## **ADDENDUM NO. 2**

Date: May 23, 2018

**Project: Hiram Johnson HVAC Replacement**

Scale: As indicated	Sheet
Drawn By: NS	<b>M2.05</b>
Checked By: JT	
Issue Date: 4/17/18	
Revit Version: 2017	
	Sheet 1 of 200

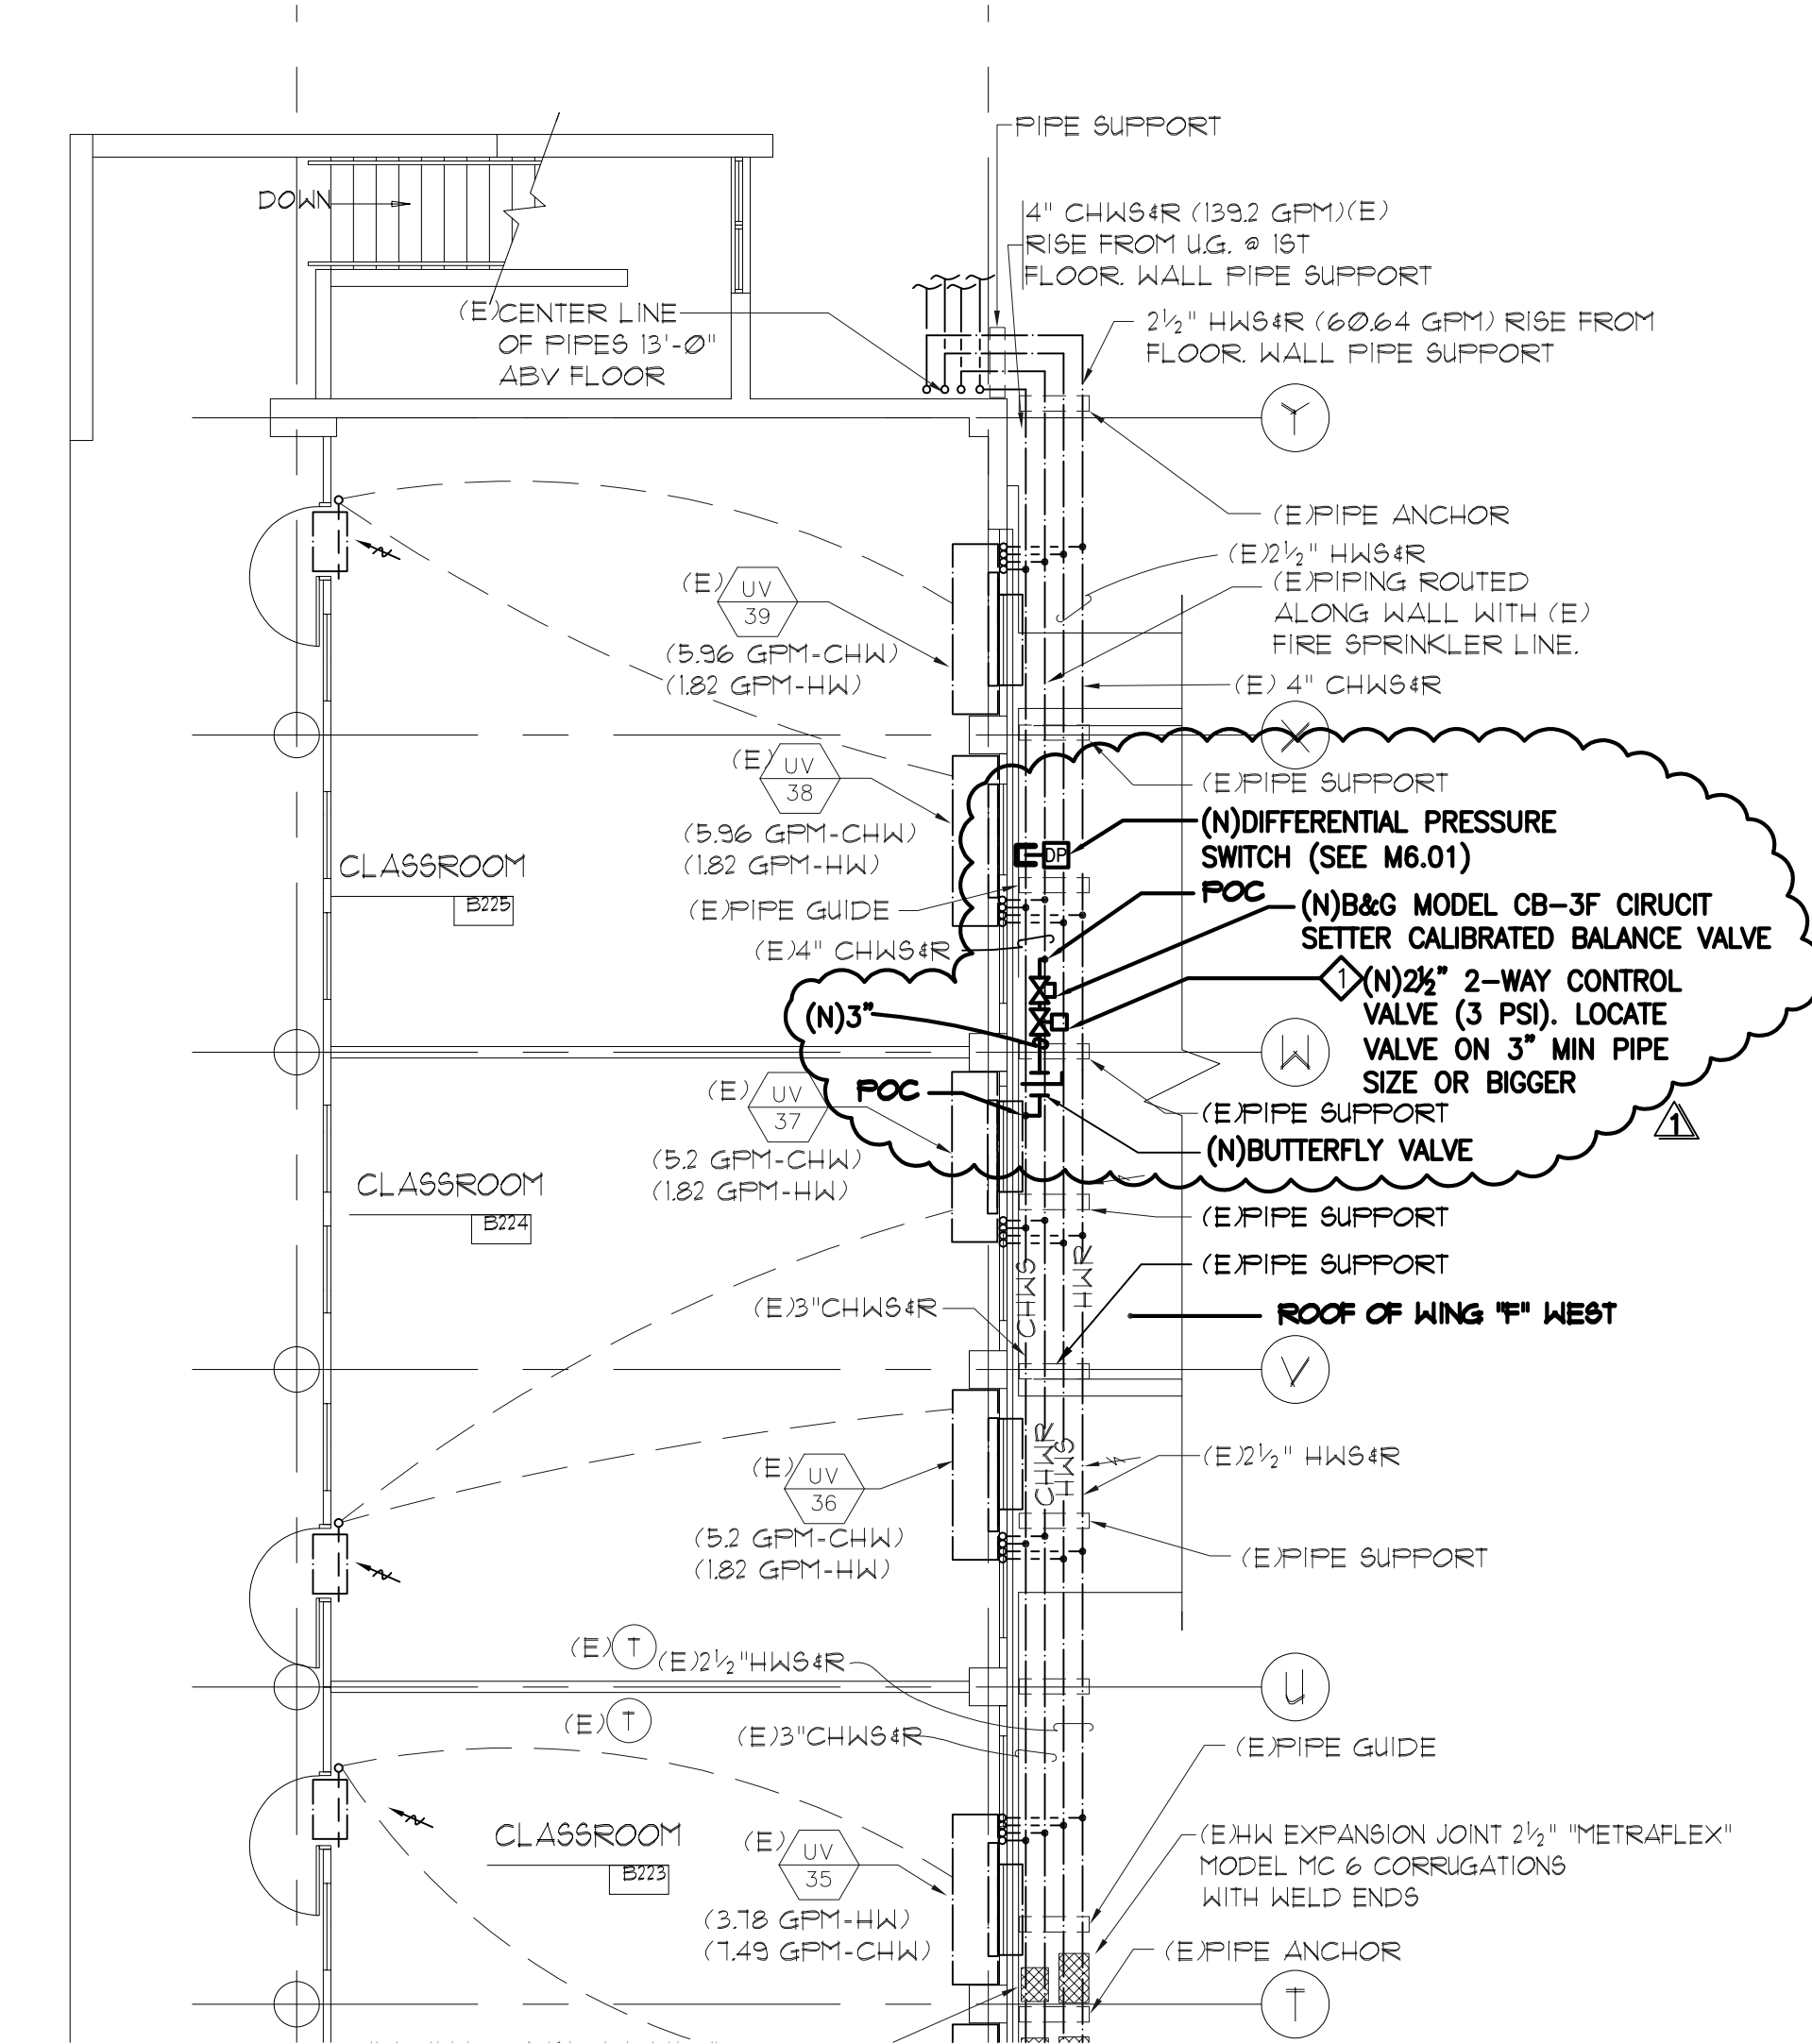
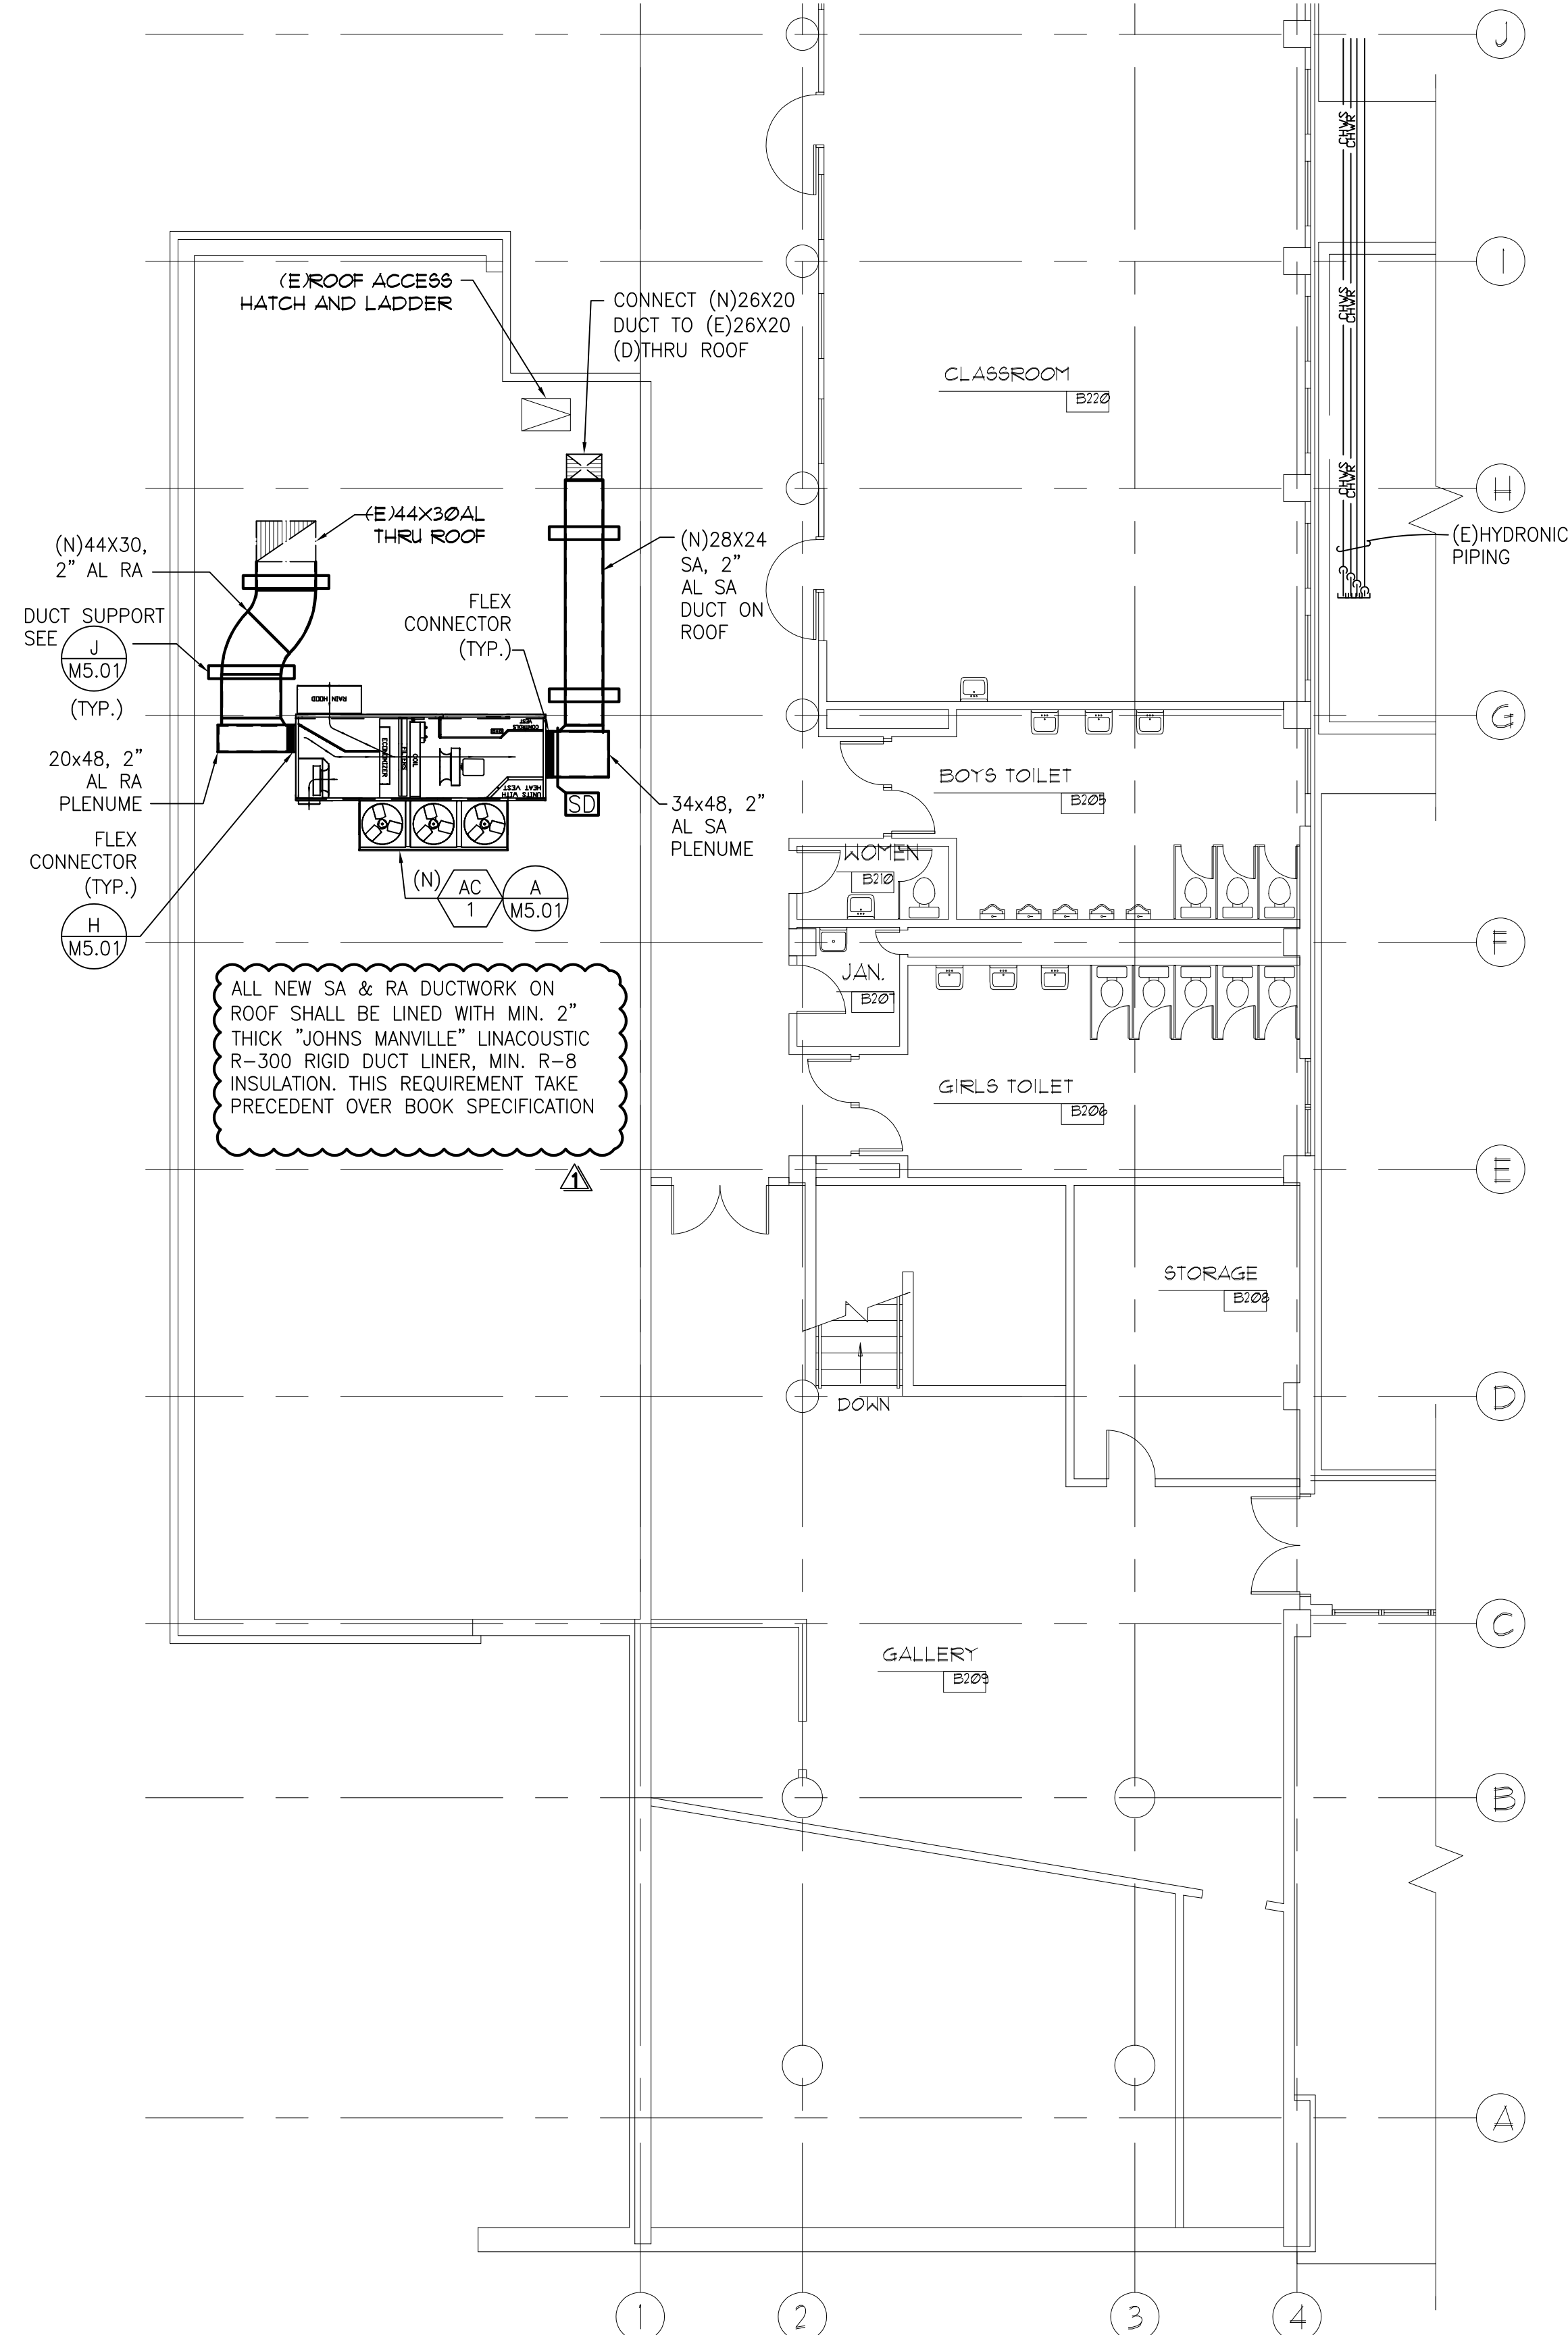
**Refer to Drawing M2.05**

**Note:** The drawing is updated to add the detail "C" showing the location of the new control valve location. Detail "B" updated to specify the linear for the ductwork on the roof.
